Access Compliance Report Public Rights-of-Way (Curb Ramps)

Main Street: ENRAMADA_DR Cross Street: WINDSOR_LN Location: NW

ADA ID: RPAT211011110719 Ramp Type: Type 6 - Directional 1 Initial Pass/Fail: Pass Overall Compliance: No Severity Score: 2

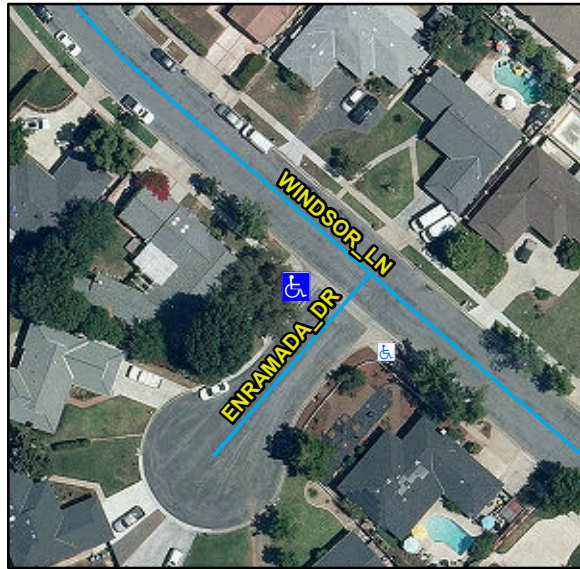
R304.5.2, STD 1115

Remove & Replace Entire Ramp.
